Office Action Summary	Application No. 10/572,184	Applicant(s) YON-HIN, BERNADETTE	
	Examiner BRYAN D. RIPA	Art Unit 1795

DETAILED ACTION

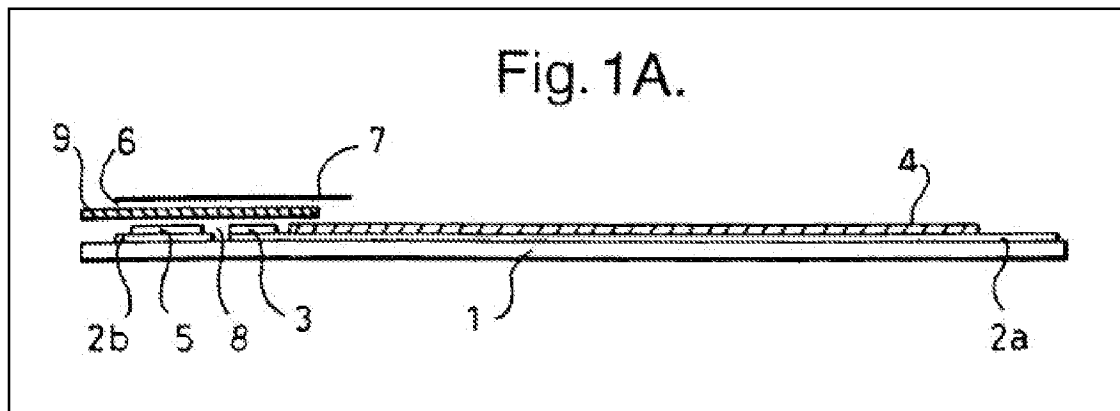
Regarding claim 1, WILLIAMS teaches a sensor comprising at least a first and a second electrode (see conductive layer 2b comprising the first electrode; conductive layer 2a comprising the second electrode) and a volume there between for receiving a liquid sample (see non-conducting gap 8) and which includes an agent that lyses cells (see col. 4 lines 35–38 discussing monofilament mesh 6 being coated with a lysing agent). See figure 1a below. WILLIAMS, however, does not teach the lysing agent being comprised in the first electrode.

Regarding claim 3, WILLIAMS teaches the sensor also comprising a spreading layer over at least the first electrode (see monofilament mesh 6). See figure 1a above.

Regarding claim 4, WILLIAMS teaches the sensor wherein a lysing agent is comprised in a layer applied onto the first electrode (see col. 4 lines 35–40; col. 5 lines 45–51; figure 1a above).

Regarding claim 5, WILLIAMS teaches the sensor wherein an enzyme and/or a mediator are applied in one or more additional layers on the first electrode (see analyte-specific reagent 5; col. 3 lines 61–67).
